**PLANNING & ZONING SECTION
STAFF REPORT**

| Case Number | 260509ZP | |
| Type of Case | PUD Amendment with Master Plan: Request to 1) allow six pickleball courts and two manufactured buildings (built without permit); 2) modify buffers; 3) modify construction access; and 4) 3) expand allowable uses to B-2, modify DRA, and modify site plan layout as submitted PUD Master Plan. | |
| Street Address/Site Location | 17996 S US HWY 301, Summerfield, FL (access parcel in Sumter County) | |

Figure 2 - Proposed PUD Master Plan

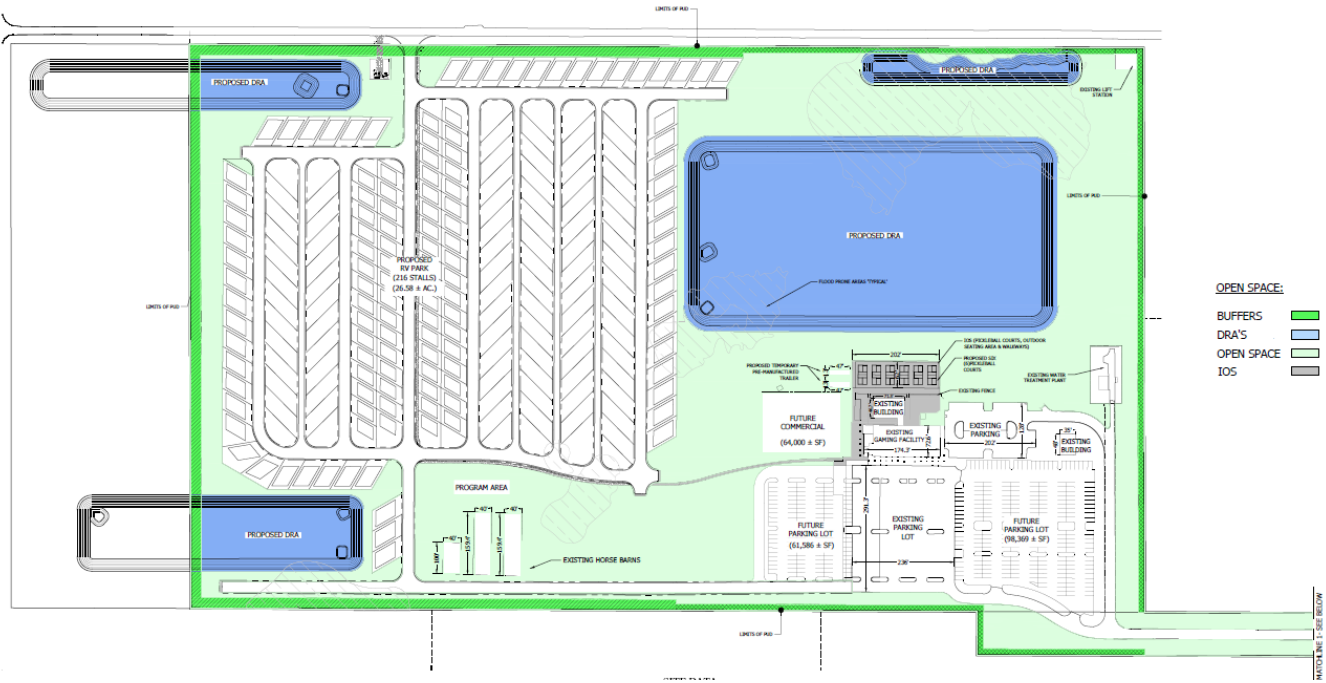
The approved PUD concept plan shows the DRAs are all located within the PUD area. However, the submitted PUD Master Plan has modifications to two DRAs. The proposed DRAs appear to be located partially on an adjacent parcel to the west. The applicant responded that the western parcel is under the same ownership as the project site and proposed a plan note citing common ownership, with easements to be recorded only if either property is conveyed separately in the future. Staff does not accept this approach. Common ownership does not eliminate the need for a recorded easement. It simply means the same owner can execute it now. Florida Statute §704.09 expressly authorizes a property owner to create and record an easement across commonly owned properties. An established easement runs with the land, not with the owner, ensuring that the drainage infrastructure remains legally encumbered regardless of any future change in ownership or conveyance. Accordingly, **staff requires recorded drainage easements for the two DRAs that extend across the subject property and the adjacent parcel to the west, prior to or concurrent with Major Site Plan approval.** A plan note citing common ownership is not a substitute for a recorded instrument.

9. **[New condition]** Where Drainage Retention Areas (DRAs) are located partially or wholly on parcels other than the project parcels (48476-001-00 and 48476-002-00), recorded drainage easements shall be established across both the subject property and the adjacent parcel(s) prior to approval of any Major Site Plan involving those DRAs. The easements shall run with the land and shall be in a form acceptable to the Marion County Stormwater section.

Figure 3 – Approved PUD Concept Plan (191106Z)

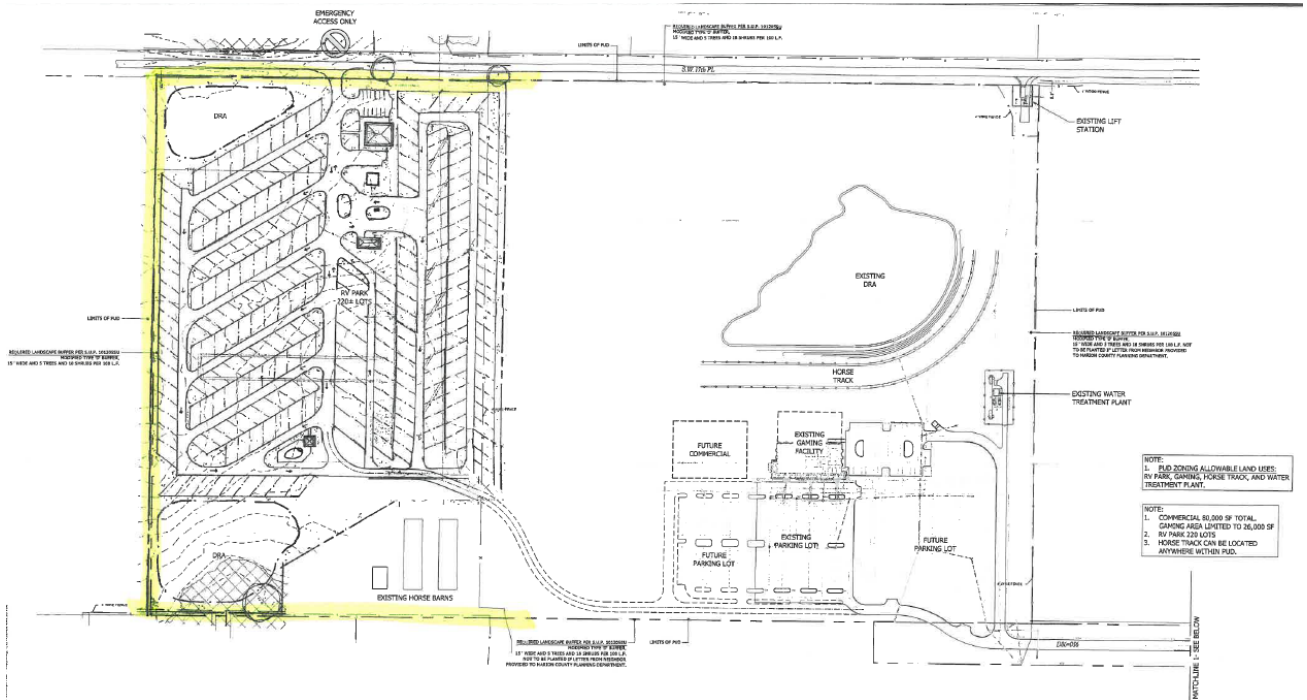
2. **Buffer Modifications:** Modify buffer conditions from those established under Resolution No. 20191106Z, specifically to remove or defer the western boundary buffer requirement, reduce the RV Park berm height from six (6) feet to three (3) feet, remove the opaque fencing requirement, and defer planting all buffers to date uncertain.
